LAKESIDE COMMERCIAL PARK SUBDIVISION, JOY SPRINGS ADDITION, RESUBDIVISION OF LOT B

APPLICATION NUMBER 6 DATE March 17, 2016
 APPLICANT Lakeside Commercial Park Subdivision, Joy Springs Addition, Resubdivision of Lot B
 REQUEST Subdivision

DETAIL SITE PLAN

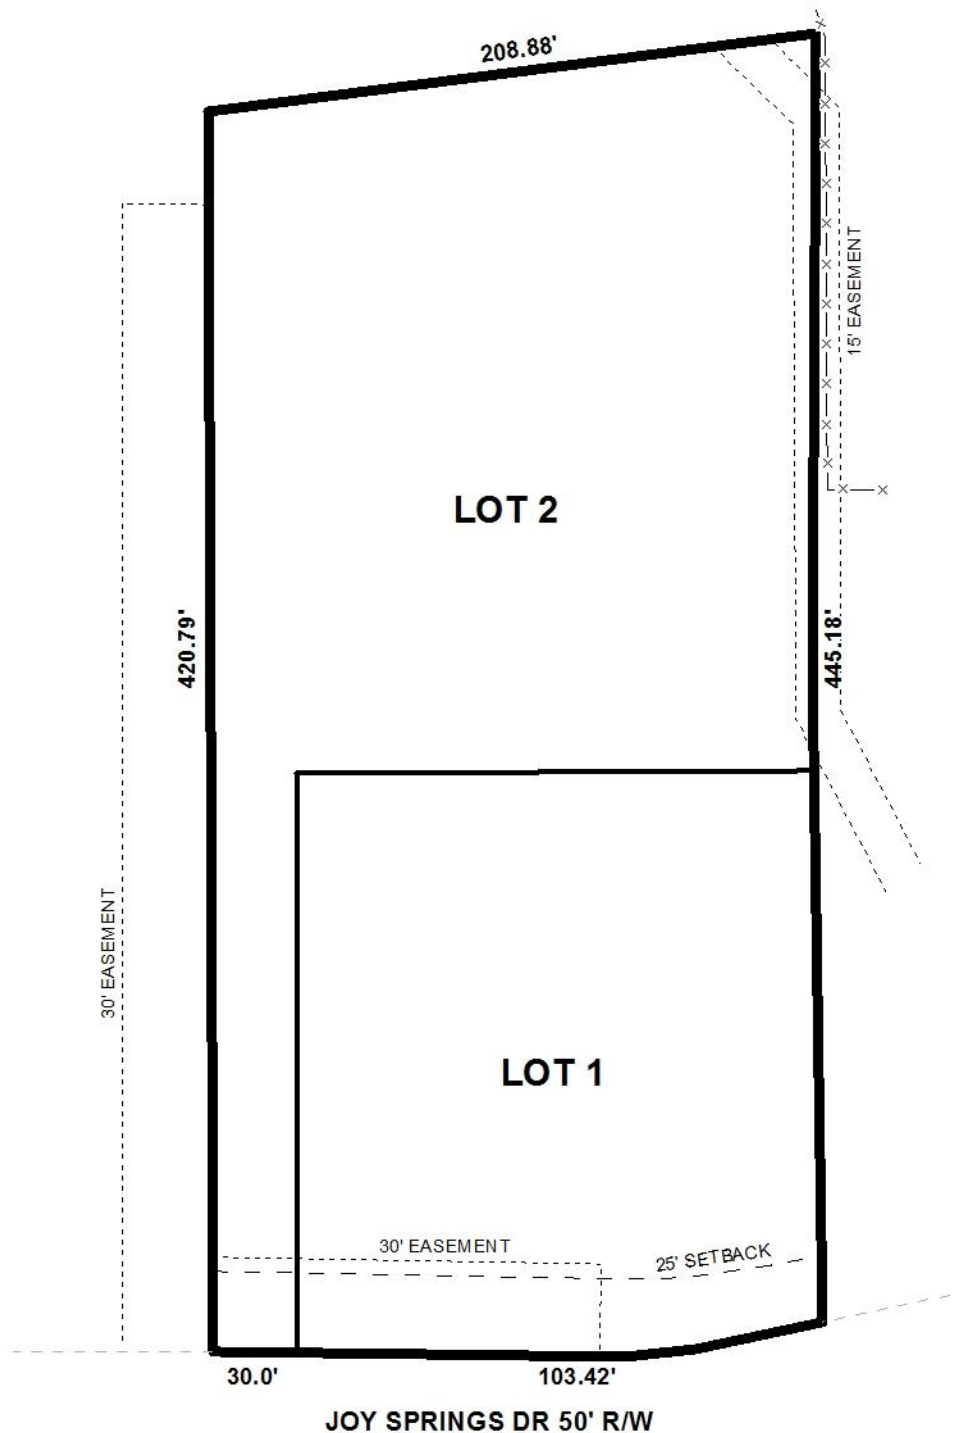
- B. Check and revise the label for existing LOT B. Arrow label shows the existing lot outside of the proposed subdivision.
- C. Check and revise the label for the existing drainage easement along the east property line.

- D. Provide and label the required witness monument(s) set for the NW corner of LOT 2.
- E. Provide the Surveyor's, Owner's (notarized), Planning Commission, and Traffic Engineering signatures.

The preliminary plat correctly illustrates a 25' building setback line for the proposed Lot 1, but should be revised to illustrate a 25' minimum building setback line for proposed Lot 2 where the lot is at least 60' wide, as required by Section V.D.9. of the Subdivision Regulations.

It should be noted that a 30' utility easement is illustrated along the front property lines of both lots, with the exception of a portion of proposed Lot 1, and a 15' drainage easement is illustrated on the east property line of proposed Lot 2. A note should be placed on the Final Plat, if approved, stating that no structures will be erected in any easement.

- 2) revision of the Final Plat to illustrate a 25' minimum building setback line for proposed Lot 2 where the lot is at least 60' wide;
- 3) retention of the 25' minimum building setback line for proposed Lot 1;
